Modification Recommended Service Note

N8941A - Autoranging System DC Power Supply, 200V, 70A, 5000W, 400 VAC

Serial Numbers: DE14290000 - DE15369999 without manufacturing ID Version "B"

5) SMT resistors R93/94 are located in red circle shown below:

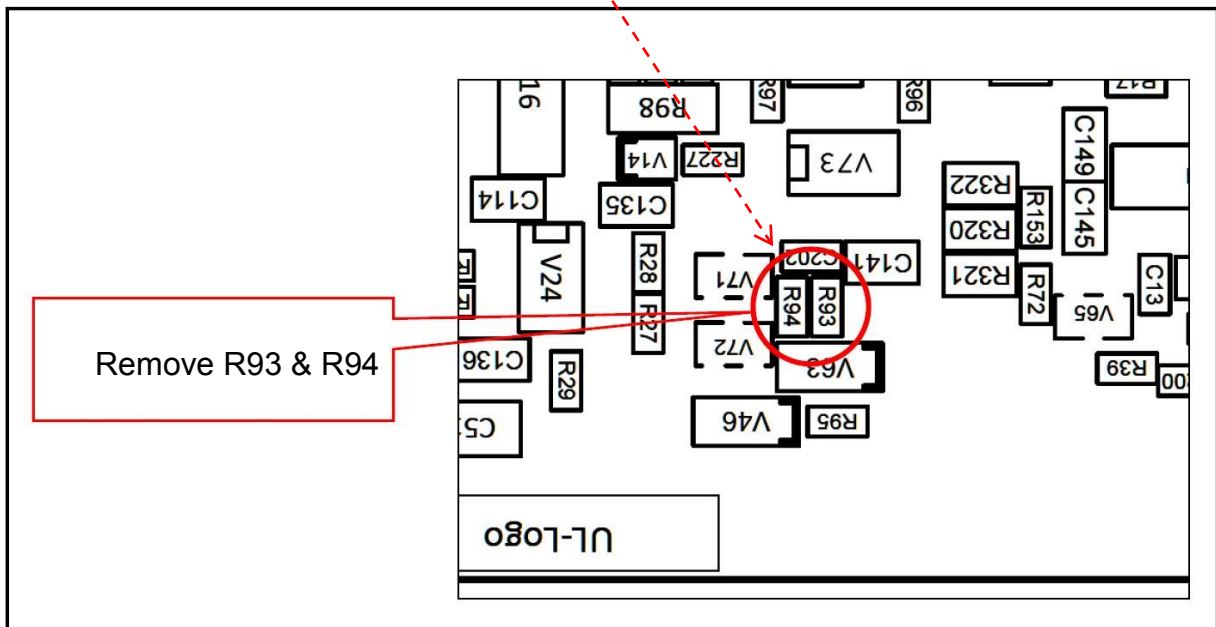
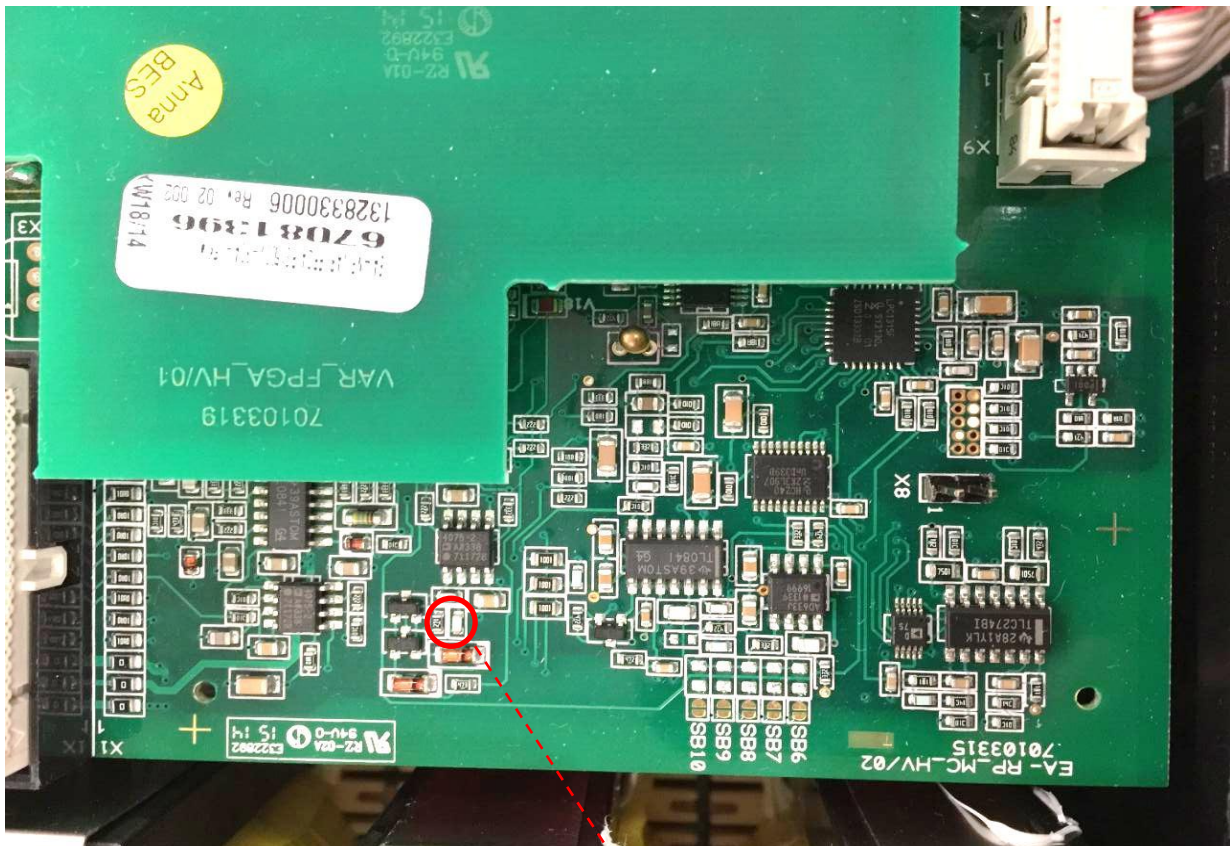
- 1) Remove acMains cable from power source.
- 2) Wait 5 minutes
- 3) Remove top cover from instrument.
- 4) In the 5kW units (viewed from the front of the unit), a small SMT assembly located at the right-rear of instrument will be readily visible (see below):

In the 10kW & 15kW units; although found in the same location, a black plastic cover will have to be removed to gain visibility and access to the SMT assembly. Plastic cover snaps-on and can be removed with a small screwdriver.

Resistors R93 and R94 must be removed, no replacement parts are required for modification.

Removal of two (2) surface mount resistors, R93 and R94, will correct this problem:

Suffix “B” added

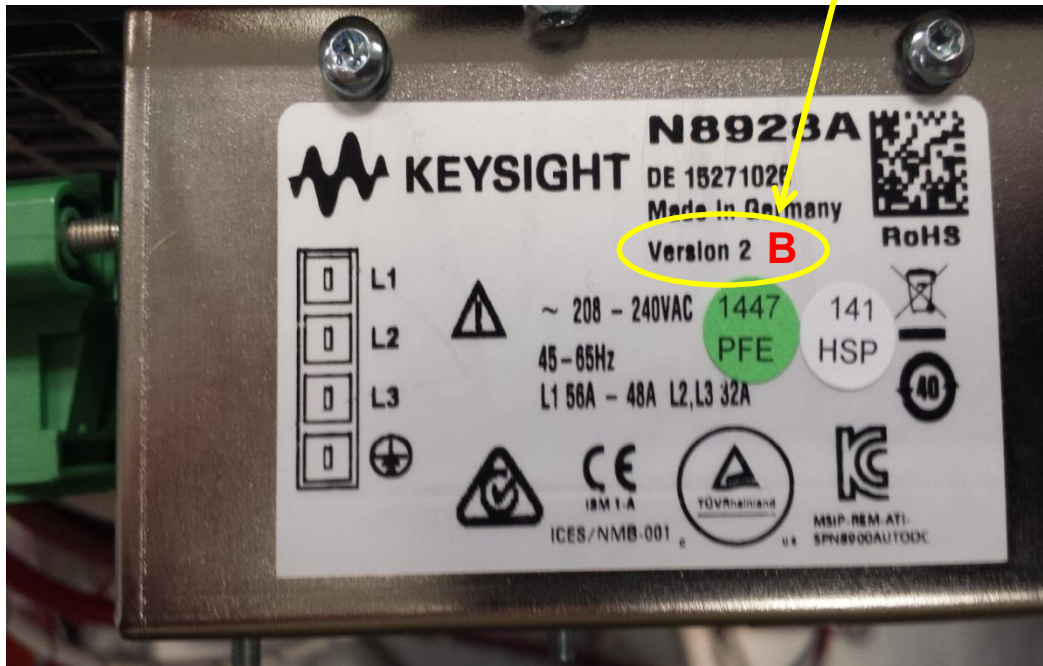
7) On the acMains label, on the rear of the instrument; use an indelible marker, to add the suffix letter “B” after the Version ID. This will assist in the tracking of modified instruments.
